The following drawing index sheet and reference drawings have been added to Volume 3.

DESIGN OF NEW STAIR FOR BETHESDA STATION - CONTRACT NO. 13-FQ1 0060-MCAP-19

RED LINE REHAB.-FRIENDSHIP HEIGHTS TO GROSVENOR - PART 6
PHASE 1B SECTIONS
SCALE AS SHOWN
DRAWING NO. A09-A-301
SHEET NO. M1272-195

PLATFORM UNDERMEZZANINE AREA NEW LIGHTING PLAN

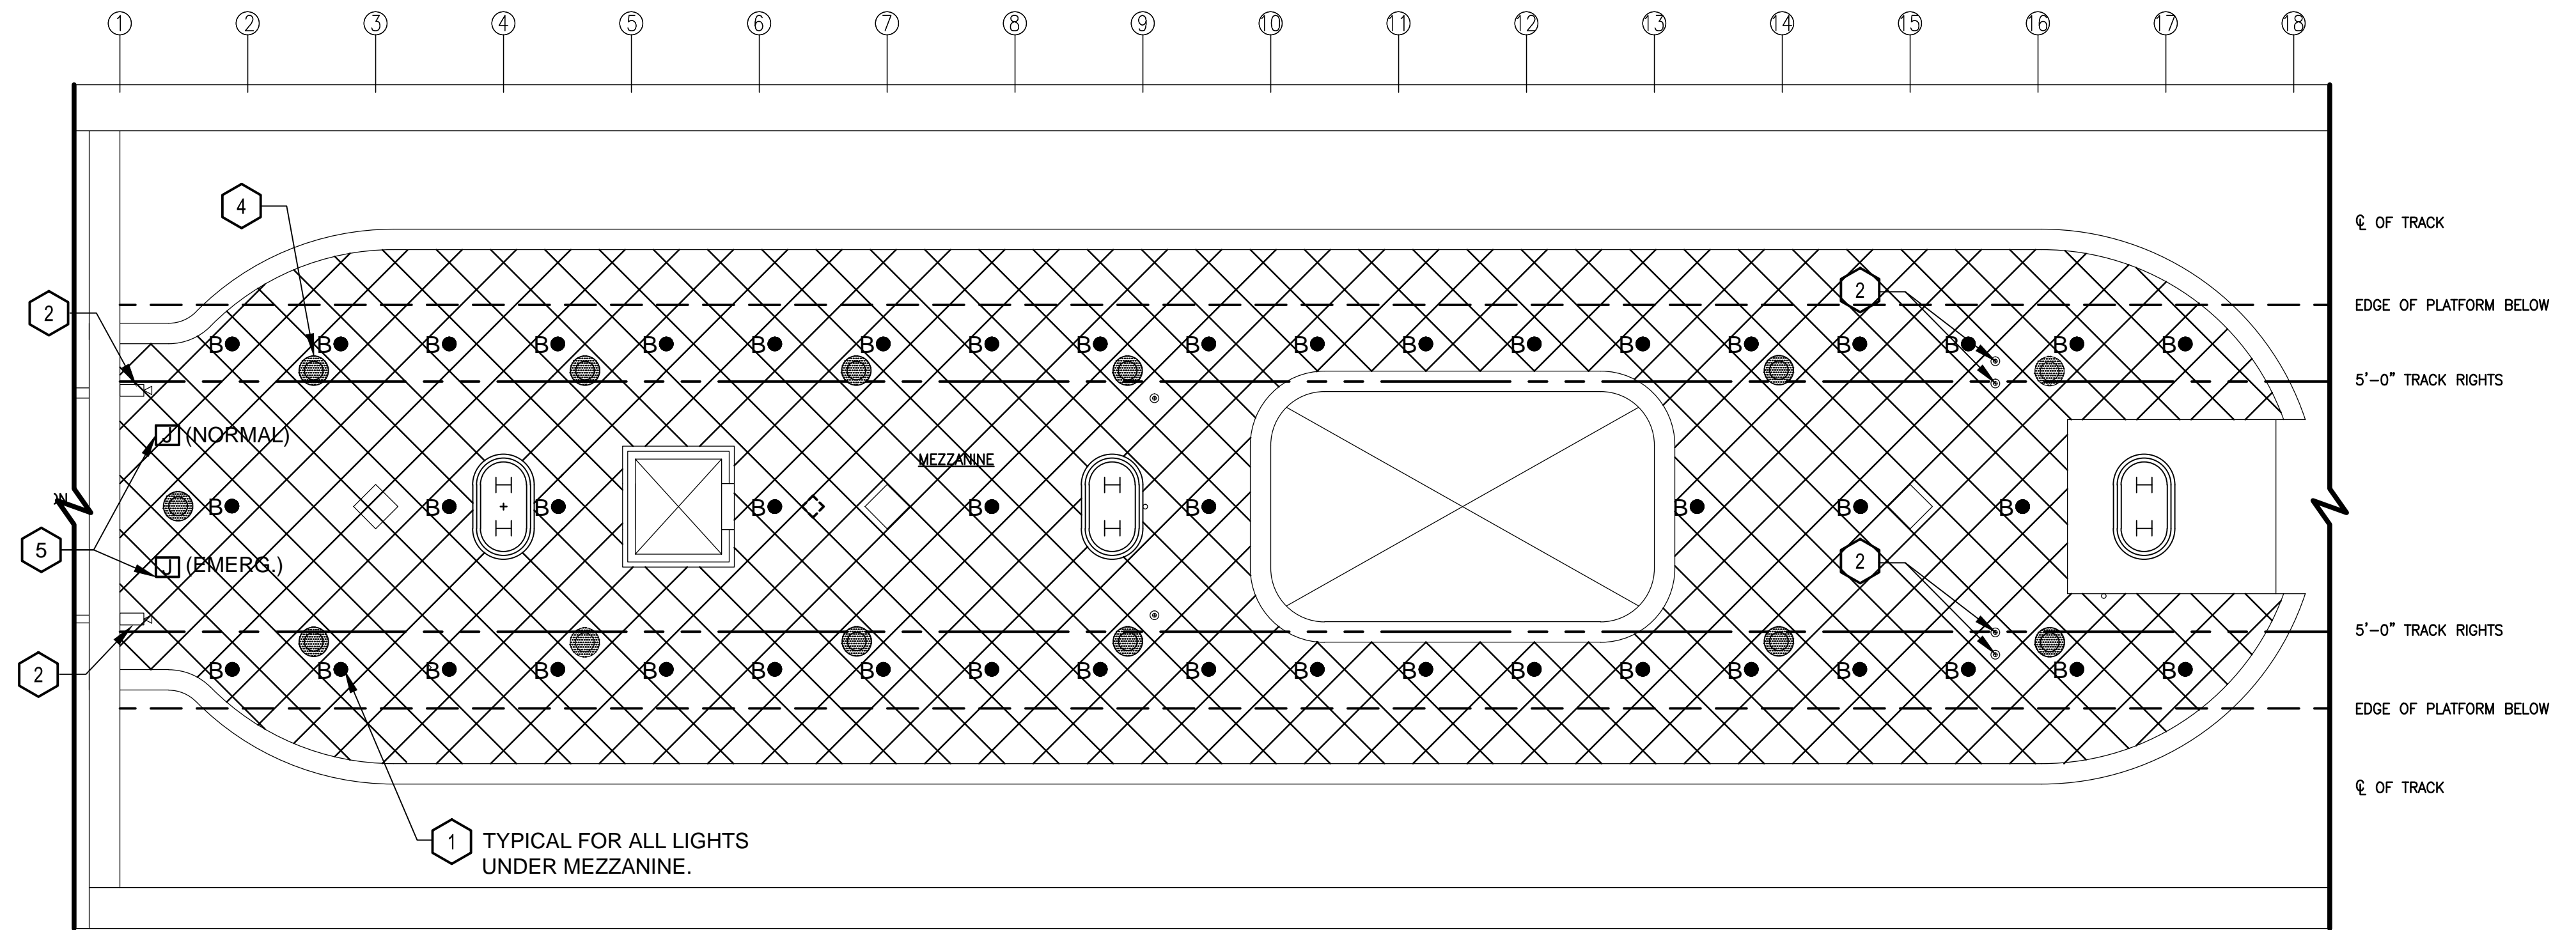
REVISIONS		
DATE	BY	DESCRIPTION
06/26/15	KI	REVISED NOTES AM 2

- 1 NEW DOWNLIGHT RECESSED IN METAL PANEL CEILING, TYPICAL.
- 2 RE-INSTALL AND RECONNECT CCTV CAMERAS REMOVED IN DEMOLITION PHASE. COORDINATE NEW LOCATION WITH CEILING ARCHITECTURAL WORK. RELOCATE ASSOCIATED CONDUIT AND WIRING AS REQUIRED.
- 3 NEW RECESSED DOWNLIGHT MOUNTED IN CONCRETE CEILING, TYPICAL.
- 4 RELOCATED EXISTING RECESSED SPEAKER, TYPICAL. TEST ALL EXISTING TO REMAIN AND RELOCATED SPEAKERS FOR CORRECT OPERATION PRIOR TO RELOCATION. REPAIR OR REPLACEMENT OF SPEAKERS FOUND DEFECTIVE SHALL BE MADE BY WMATA PRIOR TO RELOCATION OF SPEAKERS BY CONTRACTOR. CONTRACTOR SHALL TEST RELOCATED SPEAKERS AT THE CONCLUSION OF WORK.
- 5 PROVIDE NEW BRANCH CIRCUIT WIRING FROM NEW FIXTURES UP TO LAST JUNCTION BOX. REUSE HOMERUN WIRING.

RED LINE REHAB.-FRIENDSHIP HEIGHTS TO GROSVENOR - PART 2
FIRE PROTECTION DEMOLITION PLAN
SCALE AS NOTED
DRAWING NO. A10-FP-101
SHEET NO. M1272-104

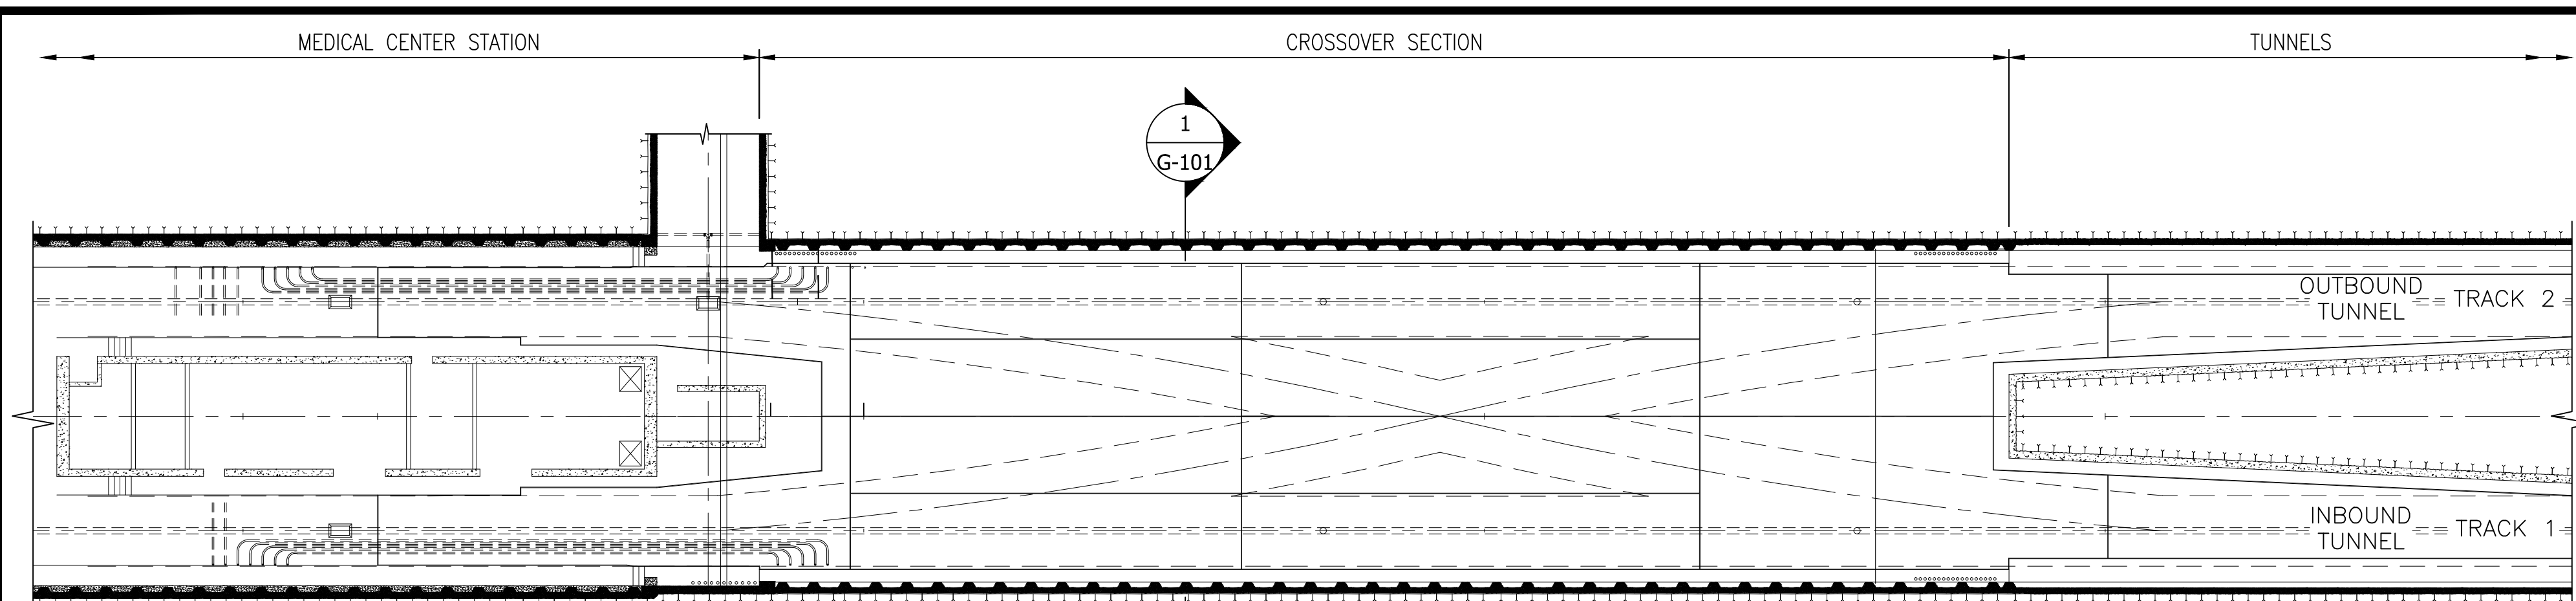
REVISIONS		
DATE	BY	DESCRIPTION
6-15	TB	ADDED PICTURES AND NOTES AM 2
